Re: Your August 27, 2010 letter

RE: C.M. Christiansen Co., Inc. (CMC), Former Pole Treatment Facility, Phelps, Wisconsin
BRRTS Activity #02-64-000068
Conceptual Plan for Addressing Military Creek Sediments

SEDIMENT REMEDIAL OPTION
 MILITARY CREEK CONCEPTUAL PLAN
 C.M. CHRISTIANSEN COMPANY
 FORMER POLE TREATMENT FACILITY
 PHELPS, WISCONSIN

FIGURE NO.
1

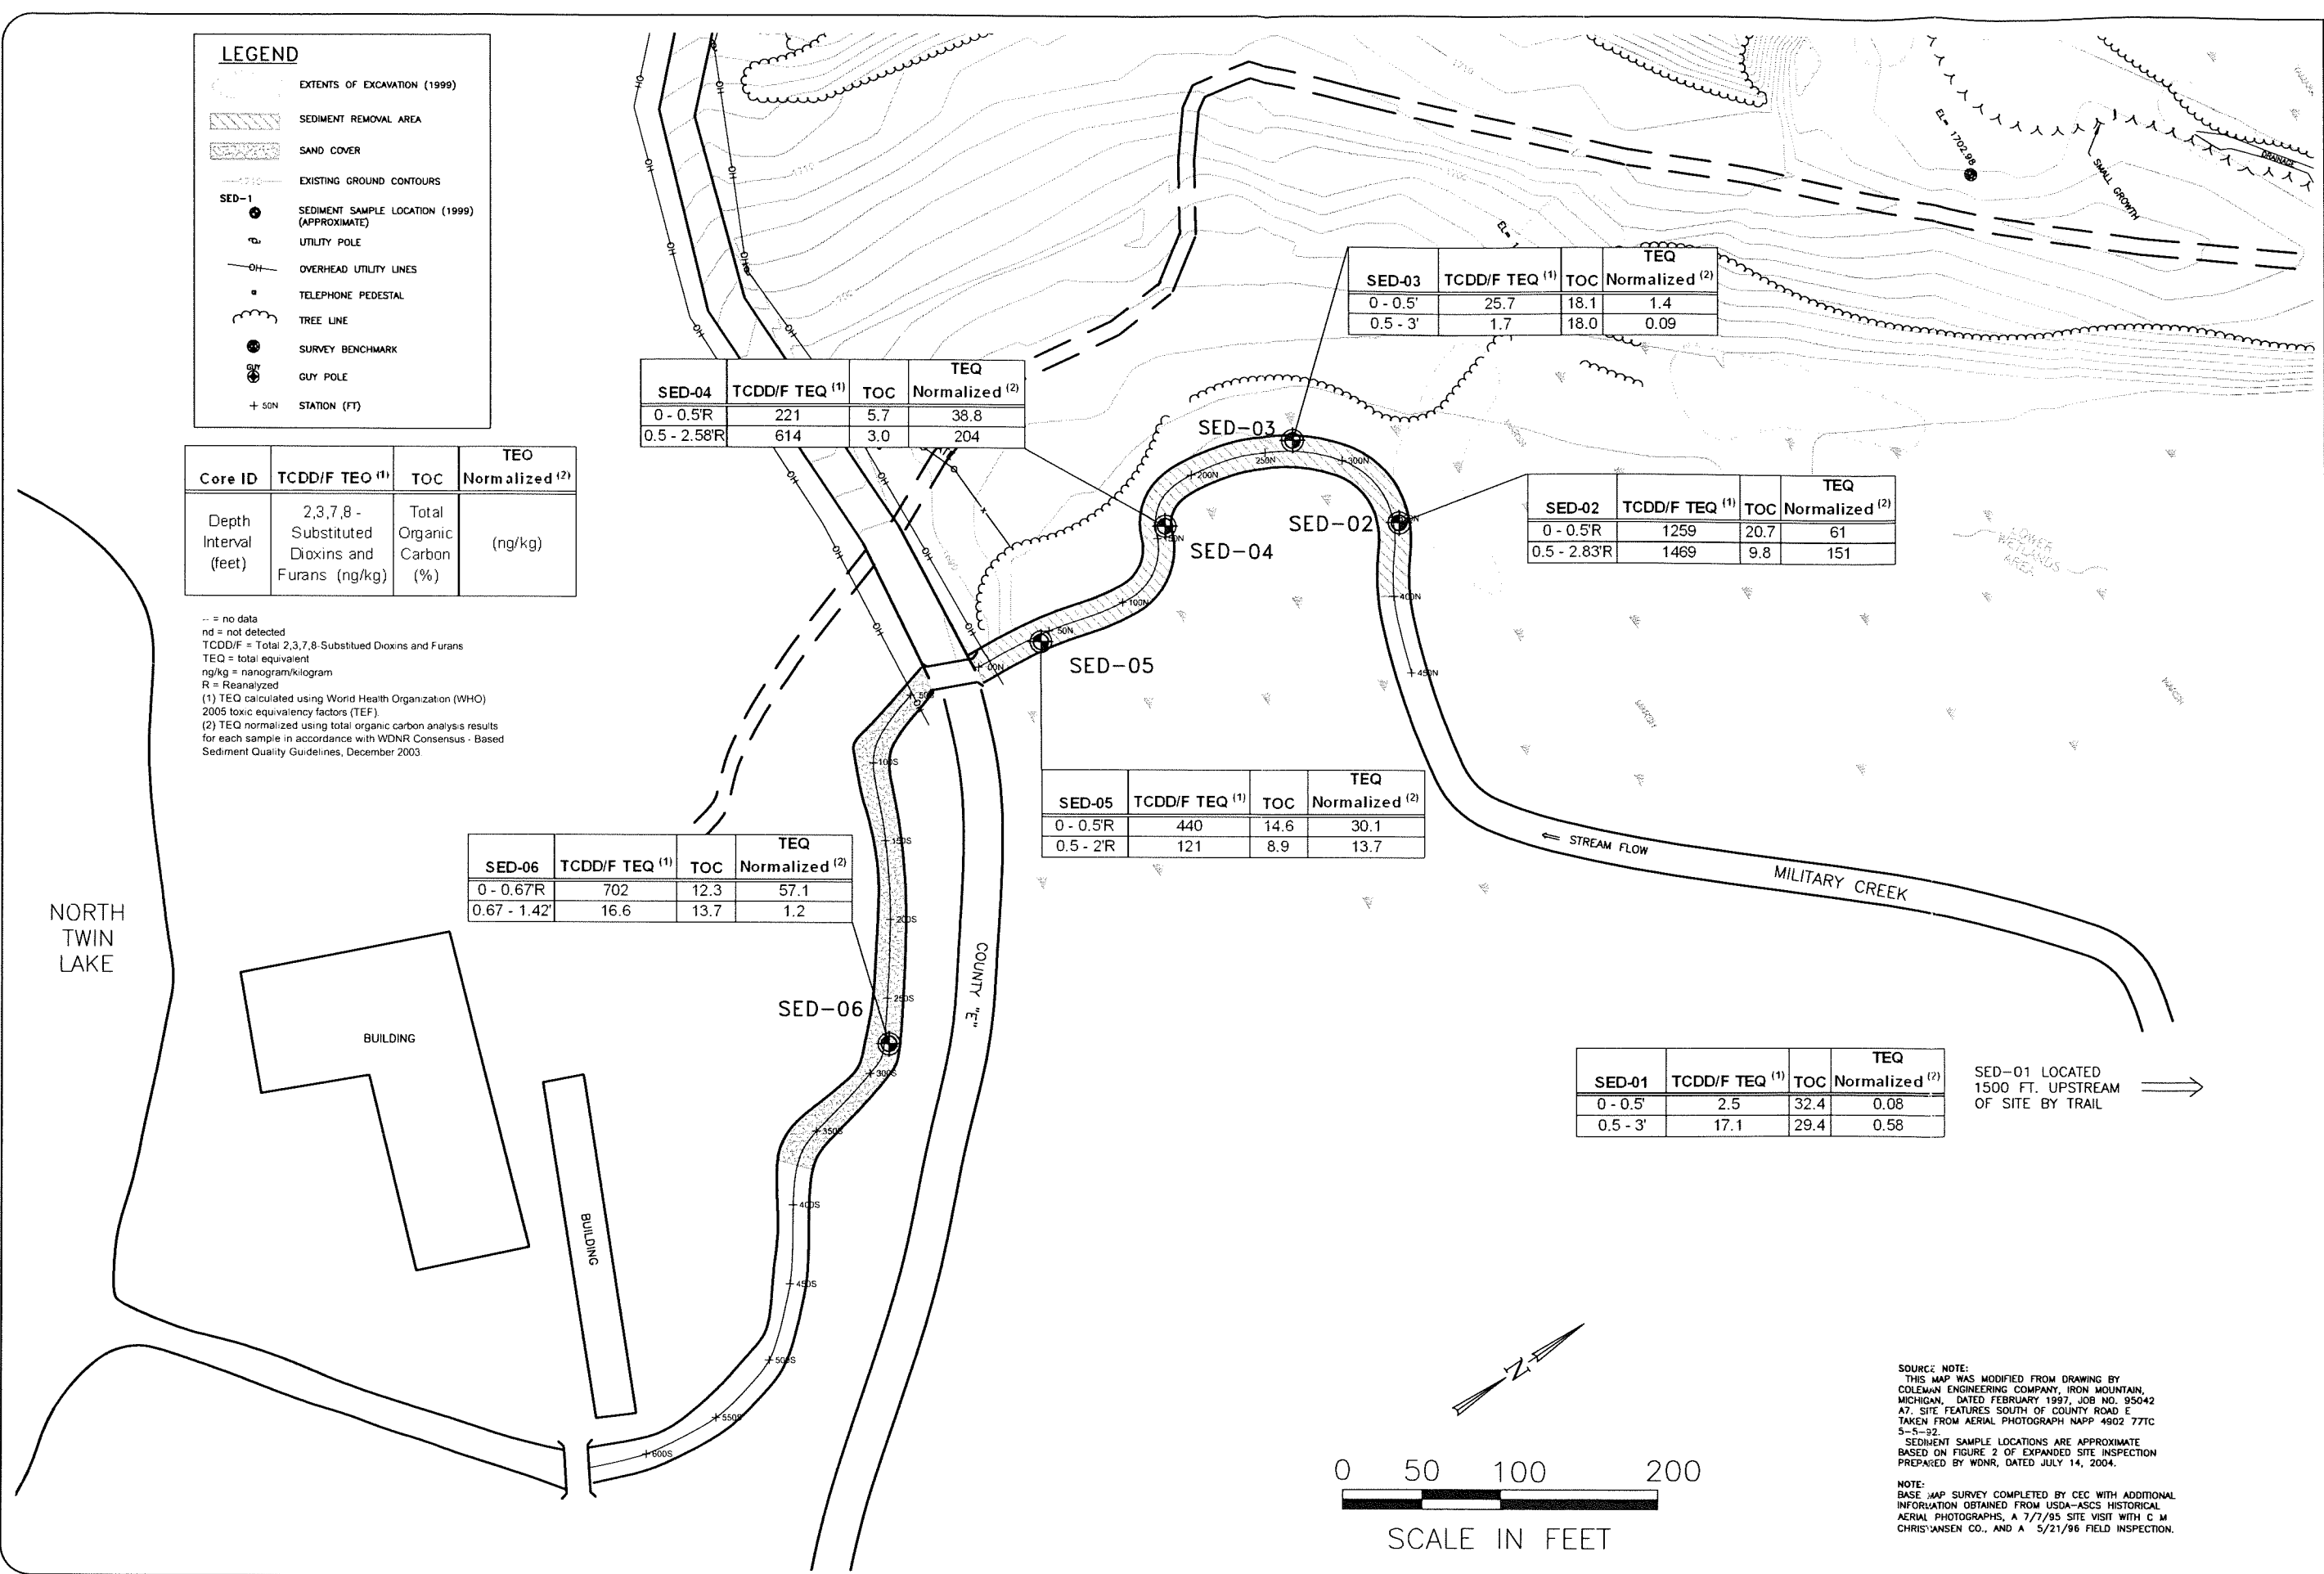
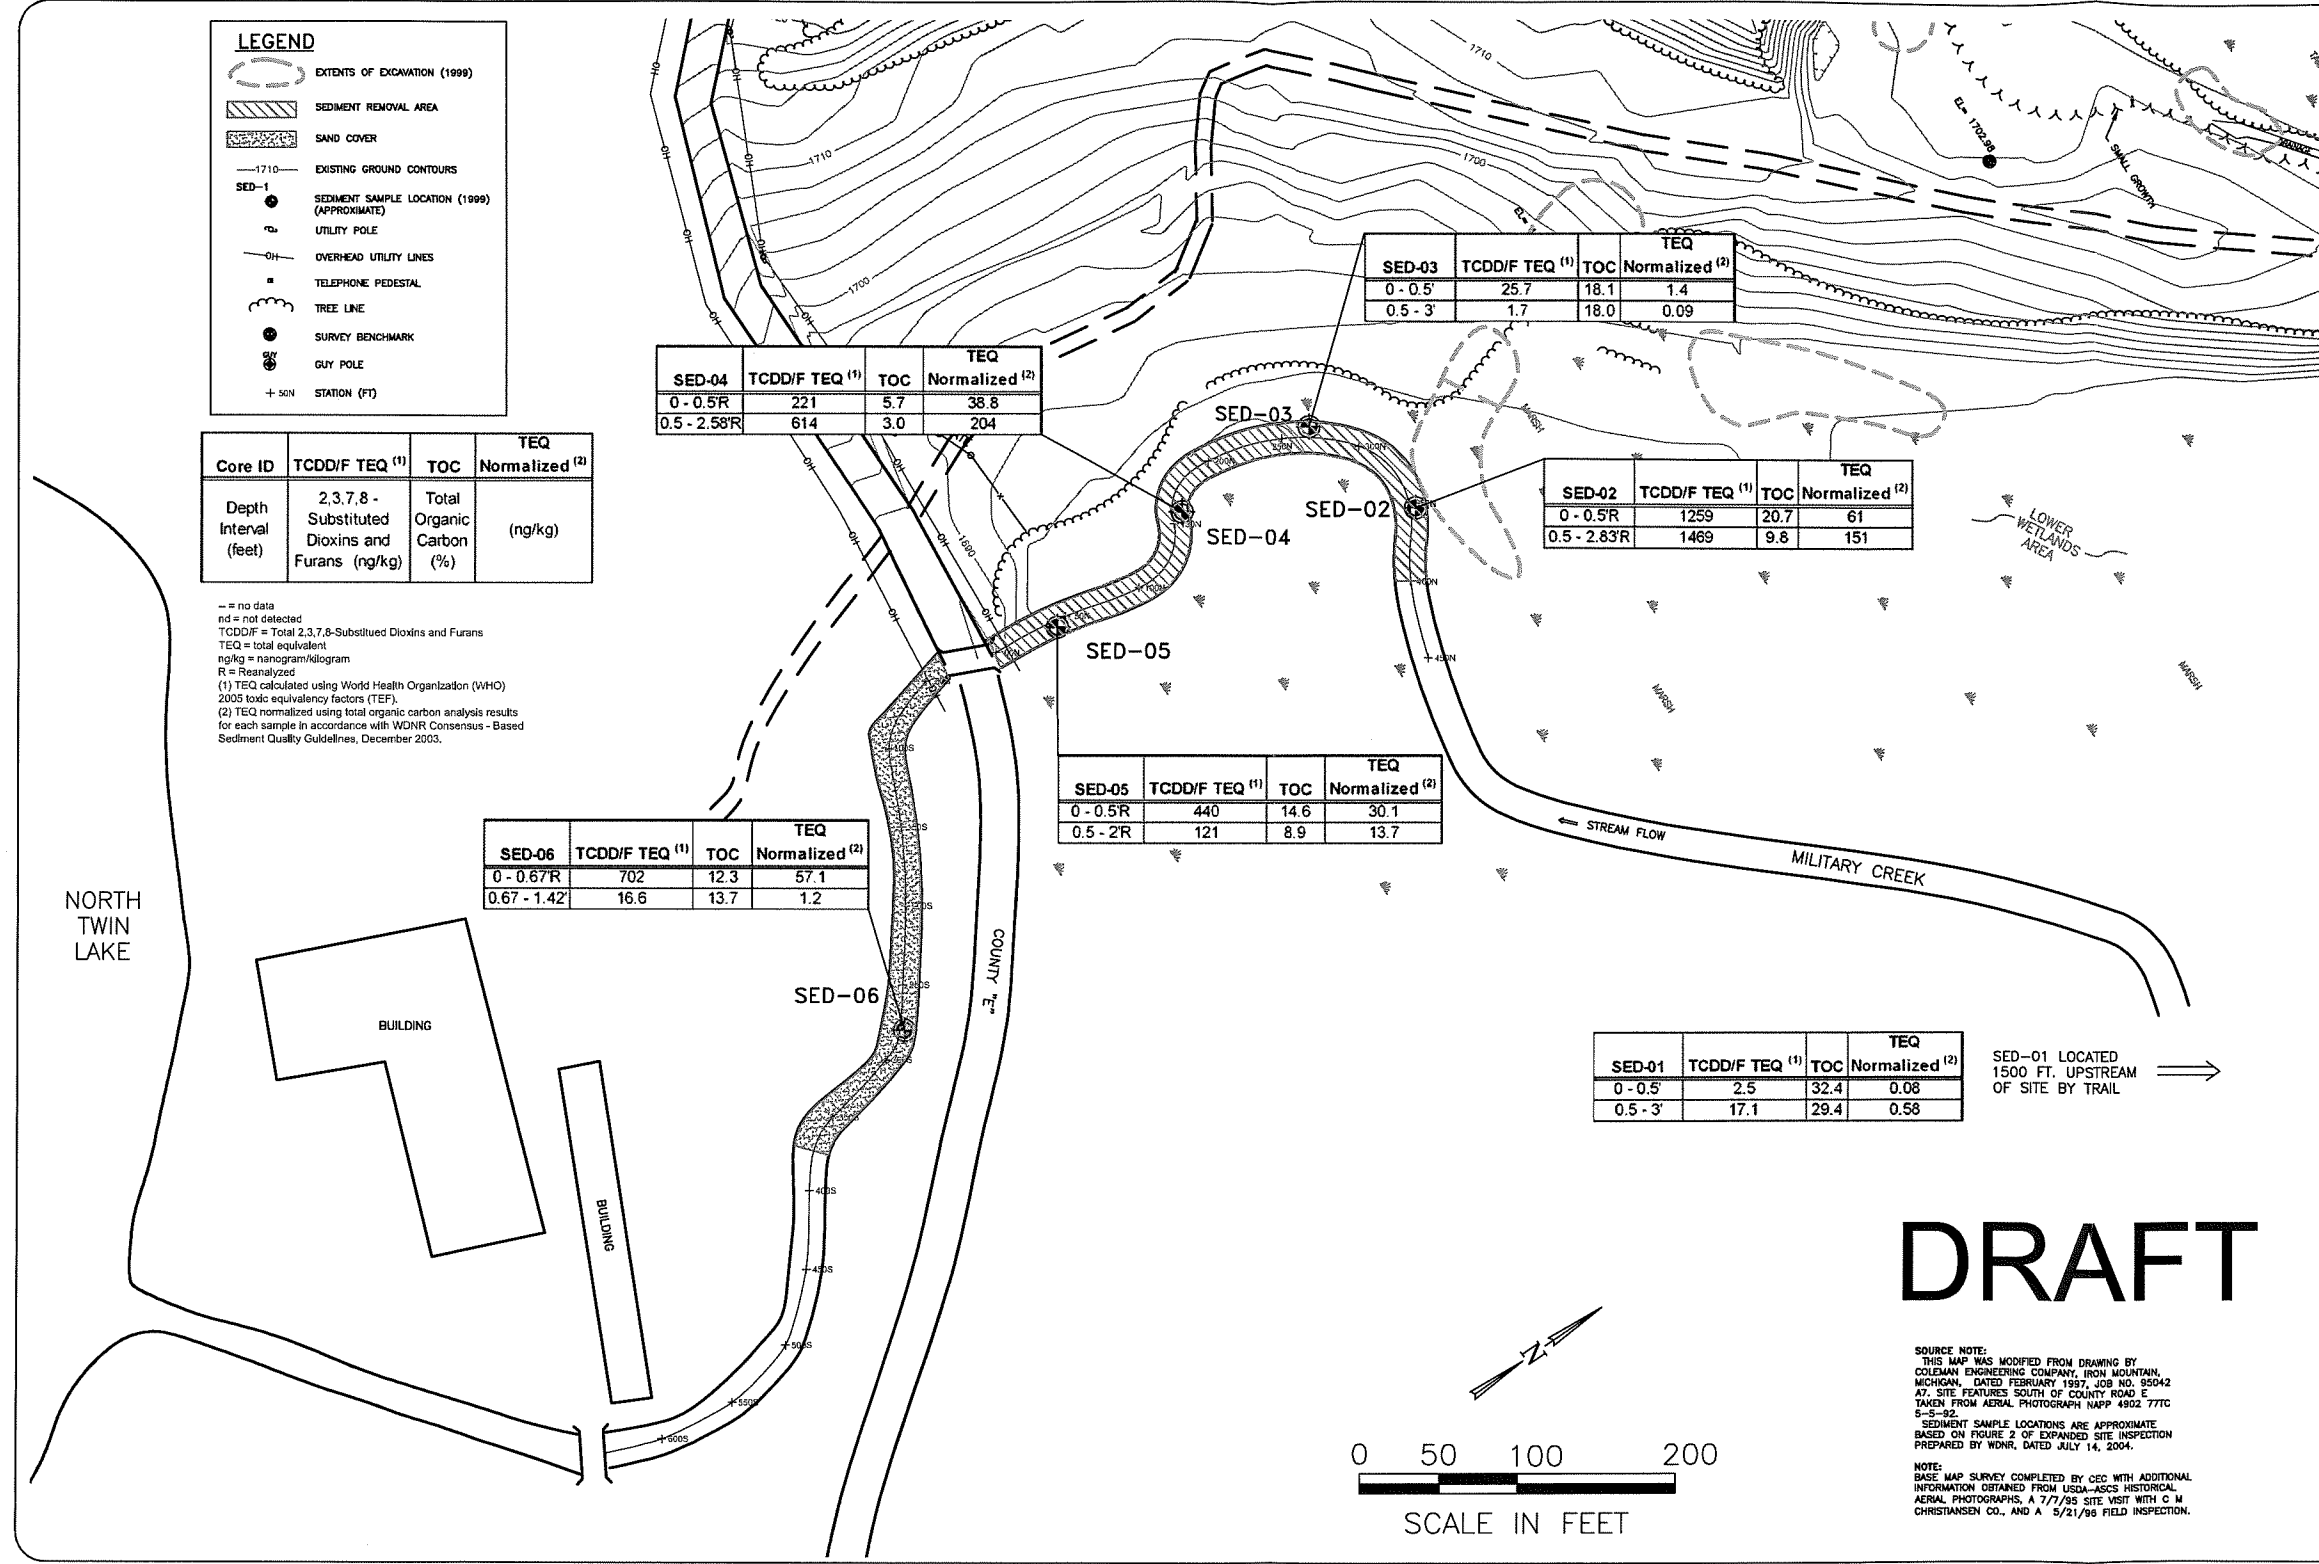
4. Regarding the question of contamination to the banks of Military Creek. As you know, a portion of the bank, closest to the former wood treating operations, has already been remediated for pentachlorophenol, which would address any co-occurring contaminants. Much of the remaining shoreline/bank area of Military Creek is heavily vegetated and stable. We in turn would have a concern about removing an arbitrary 2-foot section when it may be better to leave it intact and stabilized.

Unfortunately, we would be unable to approve a remedial action based solely upon this conceptual plan, due to several inter-related concerns. Our concerns include the proposed dredge depth, potential over-bank deposition to the bank/flood plain, future channel stability, and post-remediation sampling and monitoring. We also have concerns about the assumptions/information used to develop the proposal as it relates to the stretch of Military Creek downstream of the bridge on County Highway E. We therefore cannot provide you with concurrence that the conceptual plan will meet regulatory standards and fulfill your obligations to address the sediment contamination in Military Creek.

- We are also concerned about the stability of the creek channel in the future; it will likely not stay in the same location indefinitely. What effect, if any, will this have on post-remedial distribution of residual contaminated sediments?
- The lack of post-remediation monitoring in the conceptual plan is a major concern for the Department. Long term effectiveness and stability of the sand cover cannot be determined without monitoring.
- We view the lower segment of Military Creek downstream of the County Highway E bridge as a big unknown in terms of the degree and extent of sediment contamination. What information was used by NRT to develop their proposed downstream extent of sand cover? How is bed stability affected by a 6-inch rise in grade due to sand cover? How do we know the sand cover will remain stable, without monitoring?
